TOWN OF BOXFORD
HISTORICAL COMMISSION

Re: 12 Mortimer Road Cell Tower, Boxford, MA

From: Mike Cassidy <Mike.Cassidy@Vertexinc.com>
Sent: Wednesday, December 10, 2014 3:28 PM
To: Ross Povenmire
Subject: Varsity Site Plan

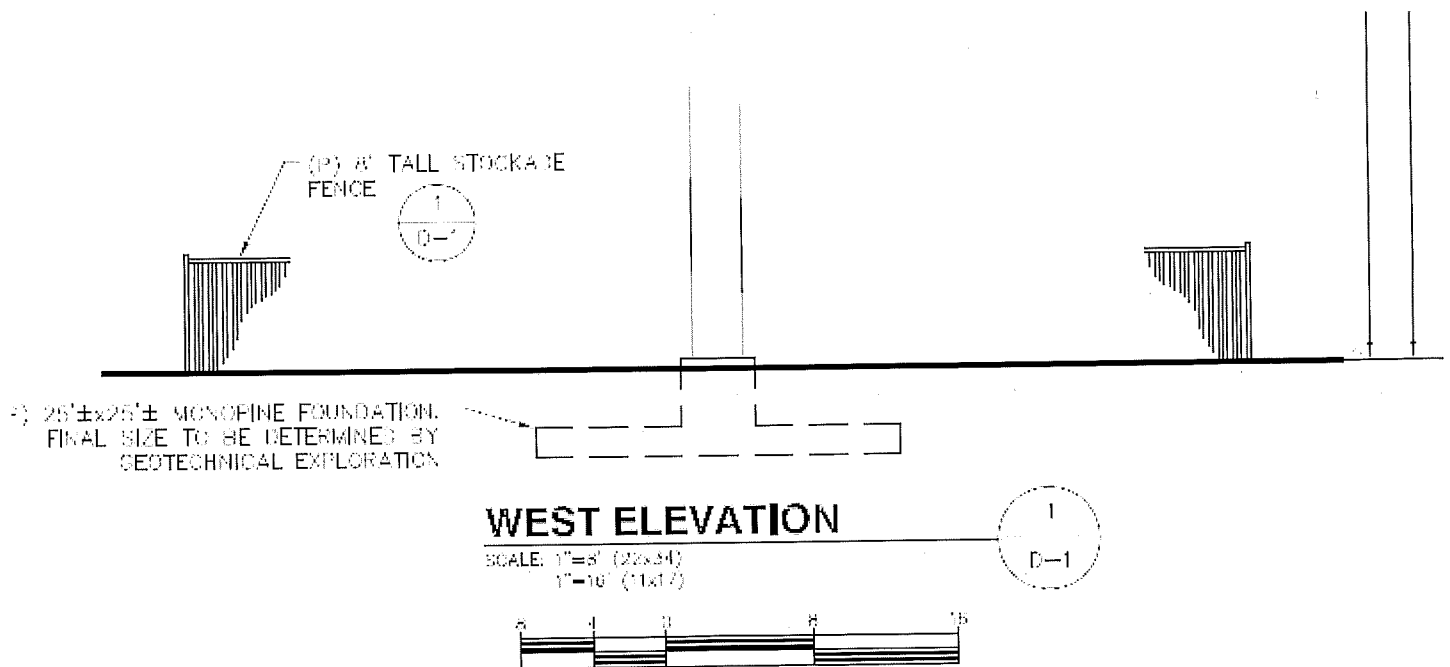
Good afternoon. I have yet another concern with the plans of this tower and they have to do with the recommended foundation. From the plans outlined below, it appears that the 25x25 foundation (concrete borings) will be 8 feet deep, which is completely inappropriate for a 150 foot structure. Research I have done states that a minimum of 25 feet is required, but most geotechnical engineers will suggest 30 to 50 feet based on requirements to stabilize the tower. I also spoke to an expert in CA, who stated that depth amounts often reach 1/3 of the tower height. I did not see any guy-anchors included in the plans, so my assumption is that this is a free standing tower. Aside from this omission, I am also concerned with what a 50 foot hole might do to the surrounding wetlands, resulting drainage and water table. I am also concerned about root structures of close by trees and other unintended consequences. Additionally, where will Varsity propose to locate the dirt removed from this hole? I would respectfully ask the commission to inquire as to these details, as this is an open-item which is not appropriately disclosed in the plans and has consequences for the wetlands area. Please note below, the plan states "Final size to be determined by the geotechnical exploration".
